APPLICATION NO.	FILING DATE	FIRST NAMED INVENTOR	ATTORNEY DOCKET NO.	CONFIRMATION NO.
10/659,736	09/10/2003	Gary M. Richter	023720-0338	3906

Office Action Summary

This is the second office action for application number 10/659,736,
Merchandising System, filed on September 10, 2003.

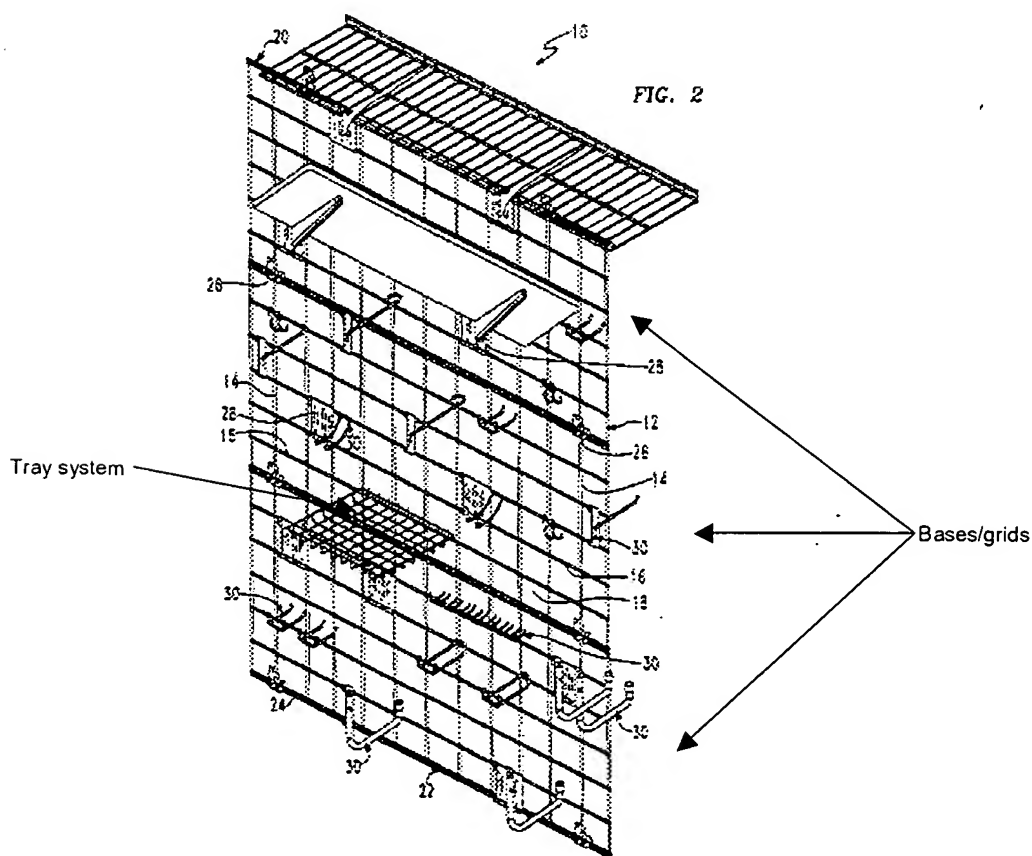
Claims 35-38, 40-43, 46, 47, 52, 54-56, 58, 59, 62, 64, 69, 70, 74, 76 and 77 are rejected under 35 U.S.C. 102(e) as being anticipated by U.S. Patent number 6,299,001 to Frovlov et al.

Frovlov et al. '001 discloses a system (above) comprising a plurality of bases/grids (above) each having a front and back and comprising separate horizontal rods (16), separate reinforcing members/supports/bars (24, above) coupled to the back of the base inherently providing rigidity to the base so that the base is inherently

resistant to deformation in more than one direction (column 3, lines 58-64), and brackets (above) coupled to the base, wherein the base further comprises separate vertical rods (14) coupled to the horizontal rods, wherein a front side of the vertical rods are welded to a side of the horizontal rods (column 3, lines 30-33), wherein similarly the vertical rods are welded to the backsides of the horizontal rods, wherein the brackets are coupled to the horizontal rods with at least one fastener (above) comprising a screw and plate (above), wherein the at least one fastener inherently allows space (above), wherein the bracket comprises hooks (above), wherein the vertical and horizontal rods are generally perpendicular to one another, wherein the reinforcement members provide support to the base, wherein the system further comprises a tray/tray system (above), wherein the vertical rods are spaced, wherein the vertical and horizontal rods are generally planar in configuration.

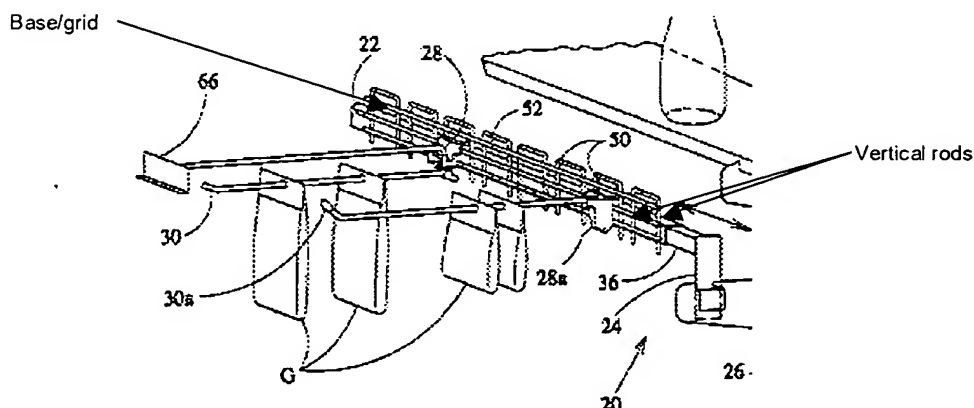
Claims 35, 36, 44, 60 and 72 are rejected under 35 U.S.C. 103(a) as being unpatentable over U.S. Patent number 6,471,079 to Berlingieri.

Berlingieri '079 teaches a system (figure 1) comprising a base/grid (above) having a front and back and comprising separate horizontal rods (52), a separate member/support/bar (22,36) coupled to the back of the base inherently providing rigidity to the base so that the base is inherently resistant to deformation in more than one direction, and brackets (28,28a) coupled to the base, wherein the base further comprises separate vertical rods (above) coupled to the horizontal rods, wherein the vertical rods are welded to the backsides of the horizontal rods (column 6, lines 10-12), wherein the member/support/bar is a square tube. However, Berlingieri '079 fails to specifically teach more than one member/support/bar. It would have been obvious to one of ordinary skill in the art at the time the invention was made to have provided more than one member/support/bar since doing so would be seen as simply a duplication of parts. See *In re Harza*, 274 F.2d 669, 124 USPQ 378 (CCPA 1960).

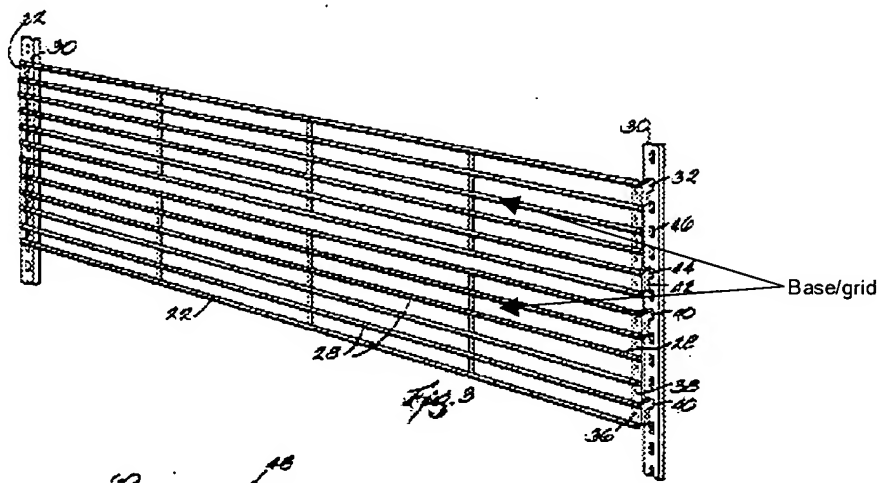
Claims 35, 53, 55, 63, 69 and 75 are rejected under 35 U.S.C. 103(a) as being unpatentable over U.S. Patent number 5,769,248 to Johnson in view of Frovlov et al. '001.

Johnson '248 teaches a system (figure 3) comprising bases/grids (above) each having a front and back and comprising separate horizontal rods (28), brackets (32) coupled to the base, wherein the base further comprises separate vertical rods (26) coupled to the horizontal rods, wherein the vertical rods are welded to the backsides of the horizontal rods (column 3, lines 5-6), wherein the system comprises a shelving system for supporting the bases (30, both sides, a "shelving system" is inherently a

system *for* shelving, so clearly, 30 on both sides function as a system for shelving).

However, Johnson '248 fails to specifically teach the system to include separate members/supports/bars coupled to the back of the base inherently providing rigidity to the base so that the base is inherently resistant to deformation in more than one direction. Nevertheless, Frolov et al. '001 teaches the previously described members/supports/bars coupled to the back of a base inherently providing rigidity to the base so that the base is inherently resistant to deformation in more than one direction. It would have been obvious to one of ordinary skill in the art at the time the invention was made to have coupled members/supports/bars to the back of the base inherently providing rigidity to the base so that the base is inherently resistant to deformation in more than one direction in the system of Johnson '248 as in Frolov et al. '001 so as to provide for a more sturdy and structurally sound system.
